VARIANCE APPLICATION SUMMARY

File Number	V-25-28
Property Address	535 HUMBOLDT CT GAHANNA, OH 43230
Parcel ID	025-009398
Zoning District	R-3 - Small Lot Residential
Project/Business Name	Bedroom Addition
Applicant	Rand Gulvas, PE (retired), LEED AP rgulvas@gmail.com 614-949-6669
Description of Variance Request	<p>Please refer to Application/Permit #BRES-25-179 which identified that the addition would encroach into the 25 foot rear yard setback. It would encroach 2 ft on the SE corner and 7 ft on the SW corner. That averages into a 4.5 foot encroachment. Per your Code " A dimensional variance is to allow a deviation of more than ten (10) percent of a dimensional or numerical code requirement such as setbacks..."</p> <p>10% of a 25 foot setback would mean 2.5 ft. So we are slightly encroaching into the allowed deviation setback by an average of only 2 feet.</p>

Statement of Variance Revised 10-29-25

Project Summary – 535 Humboldt Court

1 SITE PLAN
1" = 10'-0"

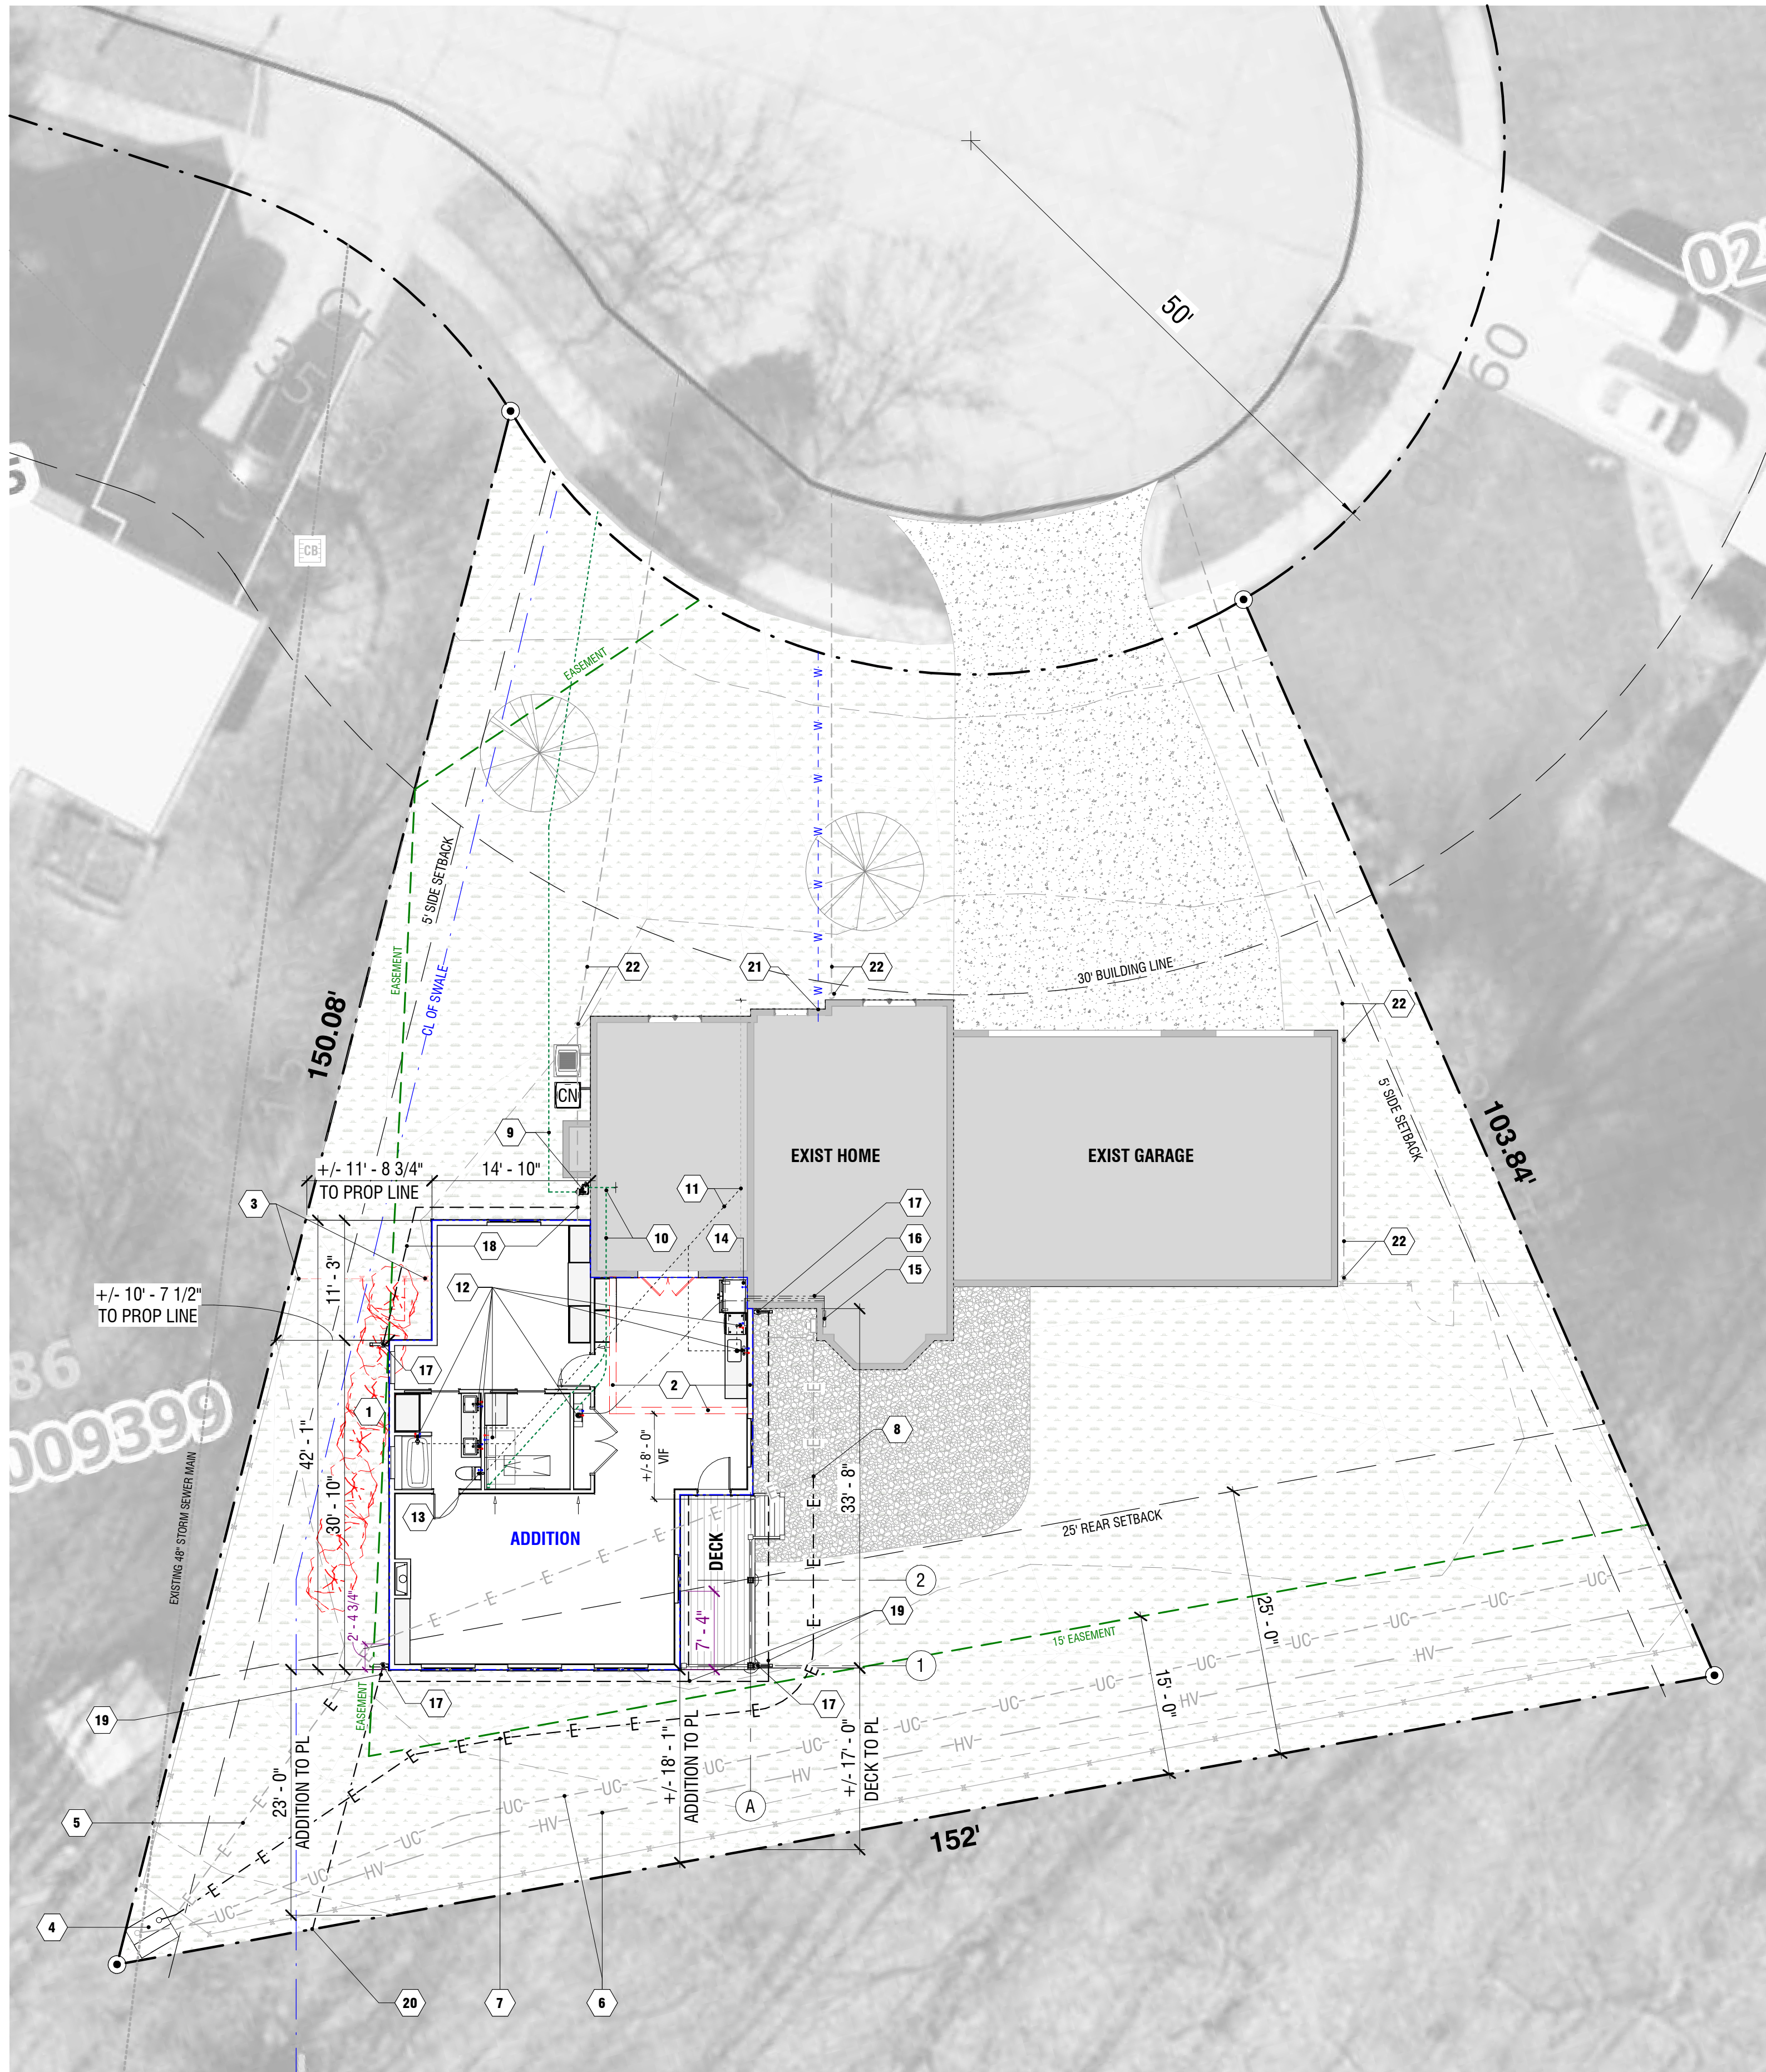
Response to Engineering comments:

#1 The Utility Easement has been added to the site drawing on the west side. Water, sanitary, electric and gas service for the addition will be through the crawl space to the house as shown on the Permit set. The house is served by water, sanitary, and gas service and downspout discharge from the street as shown. The existing electric service to the house is being replaced as shown on the site drawing. At your request we have added the existing water service from the street. We have added the downspout drain discharging to the south into the stream as ok'd by your engineer. The front gutter will intercept the existing drain pipe to the street.

#2 We have added the 40 " existing storm pipe. It has no impact on the addition.

#3 We have added the western utility easement to the site plan and the addition does not encroach into that easement.
